RE: PROPOSED WEST CULBURRA RESIDENTIAL DEVELOPMENT: RESPONSE TO UNSW WRL REVIEW – MATTERS OF MERIT.

This document provides a response to the *Independent Review on Water Quality Assessment for the West Culburra Concept Proposal (Major Project Application SSD 3846)* signed by Grantley Smith as manager of the UNSW Water Research Laboratory (WRL). Martens has been engaged by The Halloran Trust (THT) to respond to specific matters of merit raised by the review in the following sections with a separate response provided to address errors and misrepresentations within the review (P1203365JC58V01).

Attachment B – Bathymetry data by DNR (2008) – Sheet 10/28 of Plan 56228

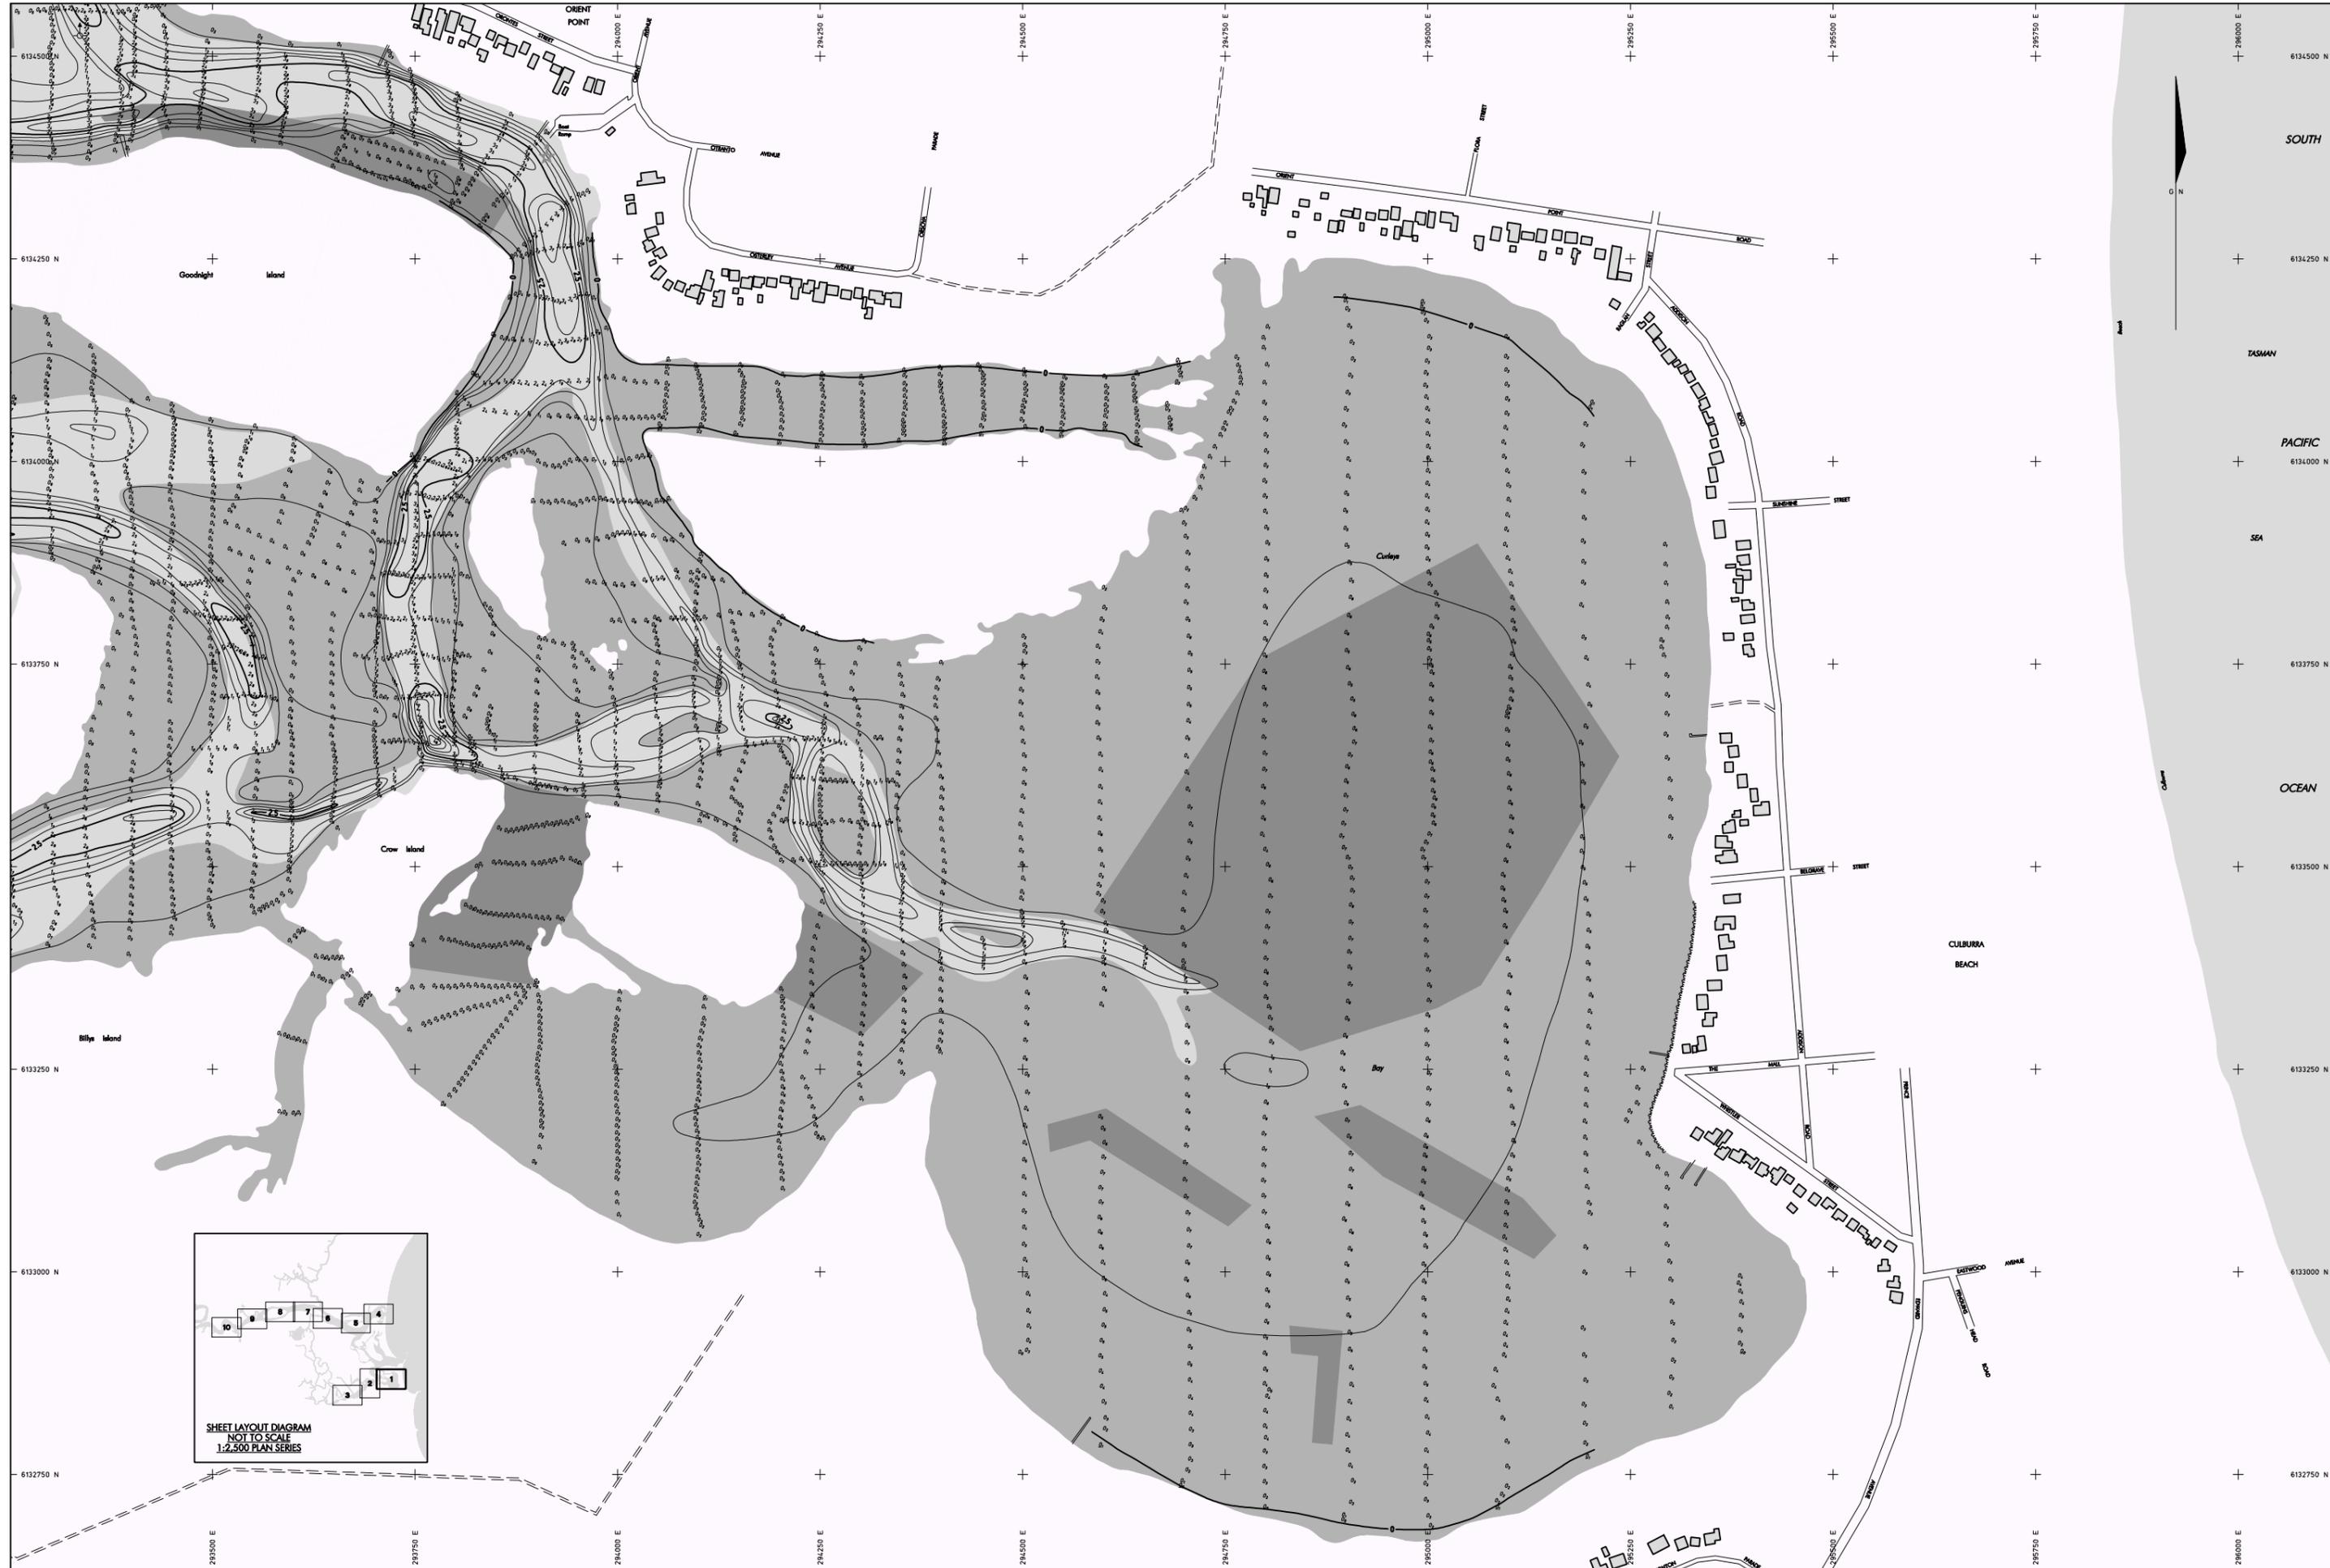
Attachment B provides a copy of the local bathymetry (levels are depth below the datum of 0.0 mAHD) of the estuary immediately north of the development. This bathymetry is provided by Department of Natural Resources and is the most current data for the area. It is the data, together with NSW LPI terrestrial LiDAR data, used in the project hydrodynamic model for TufLOW AD estuary water quality modelling. This data shows that the area between the development and wetland 351 is inundated during most tidal cycles being below 0 mAHD (which equates to mean sea level).

This information demonstrates that development on the Halloran Trust lands is separated from wetland 351 by an area inundated by estuarine waters and that much of wetland 350 is frequently inundated or similarly separated from the development by inundated areas.
